# Work Order ID 90196

Item Name: Crosstube Low Standard Aft

<b>DART AEROSPACE LTD</b>		<b>Work Order:</b>	90196
<b>Description:</b> Crosstube Low Aft (205/212)		<b>Part Number:</b>	D212-664-207
<b>Inspection Dwg:</b> D212-664-247	<b>Rev:</b> B	<b>Page 1 of 1</b>

DRAWING NO. D212-664-247	TITLE CROSSTUBE ASS'Y (205 LOW AFT)	REV. B	<b>DART AEROSPACE LTD ENGINEERING ORDER</b>		D.E.O. NO. D212-664-247-B-1	SHEET NO. SHEET 1 OF 1	SCALE NTS
DRAWN <i>QD</i>	CHECKED <i>ASS</i>	MFG. APPR. <i>AB</i>	APPROVED <i>WD</i>		DE APPR. <i>AB</i>		
DATE 11.07.15	DATE 11.07.20	DATE 11.07.21	DATE 11/07/21		DATE 11.07.21

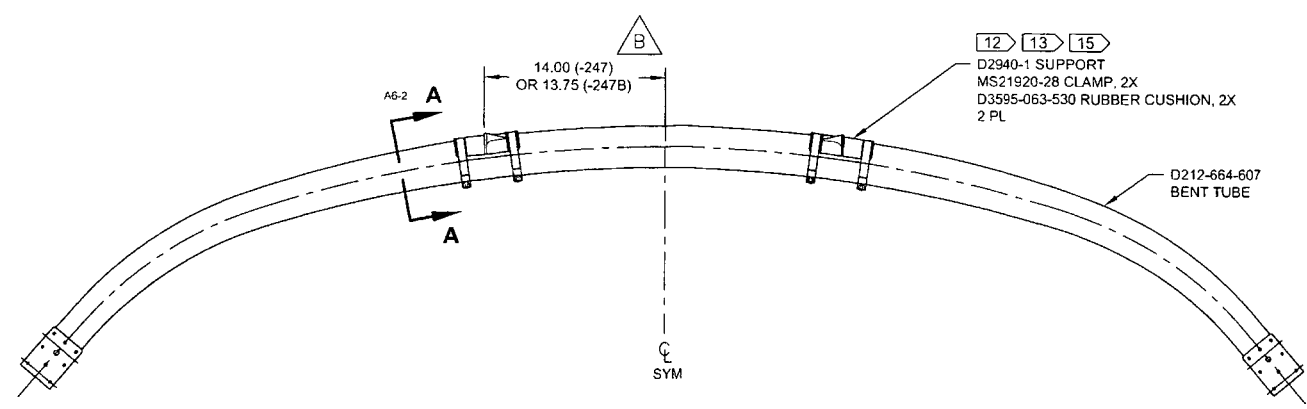
REPLACE MAGNOBOND WITH PROSEAL.

NOTE 12 & 15, SHEET 1 IS AMENDED AS FOLLOWS:

- 12) TO INSTALL D2940-1 SUPPORT: ABRASE MATING SURFACE OF SUPPORT AND CROSSTUBE WITH 180-GRIT SANDPAPER AND REMOVE RESIDUE WITH MEK (OR EQUIVALENT). APPLY A 0.04" TO 0.07" THICK LAYER OF PROSEAL 890 CLASS B-2 (OR AMS-S-8802 CLASS B-2) SEALANT TO MATING SURFACE OF SUPPORT.
- 15) TORQUE CLAMPS 80 TO 100 IN-LB. ENSURE AT LEAST 1.5 THREADS SHOWING IN SAFETY AND THAT NUT HAS NOT BOTTOMED-OUT AFTER TORQUING. **PRIOR TO PACKAGING, RE-CHECK TORQUE ON CLAMPS AFTER PROSEAL 890 SEALANT HAS CURED FOR 72 HOURS.**
